SERVICE BULLETIN No. 292 26 2882

Subject:
Replacement of a batch of potentially non-conforming fire detectors.

APPLICABLE ENGINE / VARIANT(S)	EFFECTIVITY CODE	MAINTENANCE LEVEL	CONDITION OF APPLICATION	EFFECT ON OPERATION
ARRIEL 2 B - B1 - C - C1 - C2 - C2- CG - C-PM - D - N	2-1	1,2,3	Check the presence, on your fleet, of the fire detector Serial Numbers (S/N) as specified in the Appendix A*, in 30 FH (Flight Hours) or 60 days from the issue of this Service Bulletin (first limit reached).	Replacement of fire detectors.
			<p>For the engines that have at least one fire detector given in the list in the Appendix A*: Replace the concerned fire detector(s):</p> <ul style="list-style-type: none"> • before 9 months for the engines installed on single-engine airframes, • before 12 months for the engines installed on twin-engine airframes and for engines in stock, <p>from the issue of this SB or before the next installation of the engine on the airframe (first limit reached).</p>	
		4	<p>For fire detectors in stock given in the list in the Appendix A*: Discard the concerned fire detector(s).</p> <p>Discard the concerned fire detectors before delivery of the engine.</p>

2.5.1. Conditions of application on engines

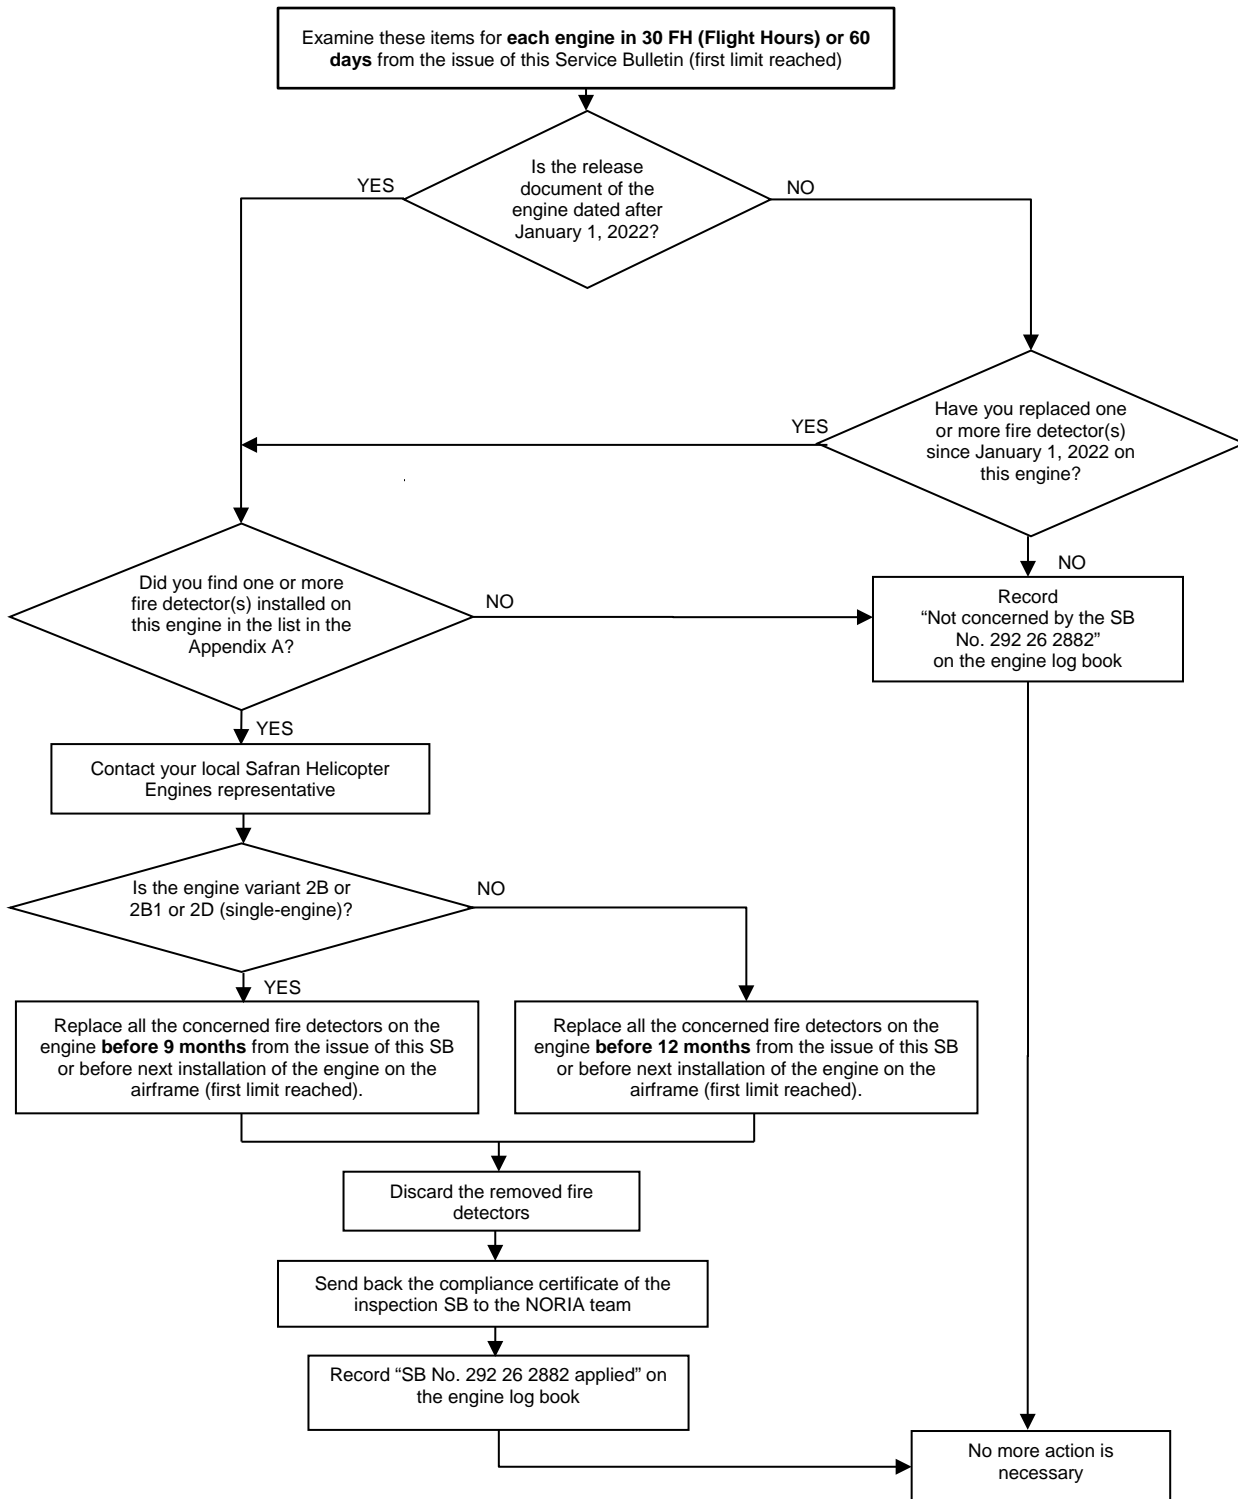
2.6.2.1. Do a check, as specified in paragraph 2.5, of the fire detector S/Ns given in the list in the Appendix A* to know if they are installed on your engines.

- 2.6.2.1.1. If the fire detector S/Ns given in the list in the Appendix A **are not installed** on your engines **or if they are not in stock**, do not do this SB.
- 2.6.2.1.2. If the fire detector S/Ns given in the list in the Appendix A **are installed** on your engines:
 - Contact your local Safran Helicopter Engines representative.
 - Replace the fire detectors with compliant fire detectors: Refer to the applicable ARRIEL 2 Maintenance Manual, task 26-11-00-900-801.
 - Refer to paragraph 2.6.4 for identification.
 - Discard the removed fire detectors.
- 2.6.2.1.3. If the fire detector S/Ns given in the list in the Appendix A are in stock:
 - Contact your local Safran Helicopter Engines representative.
 - Discard the fire detectors.
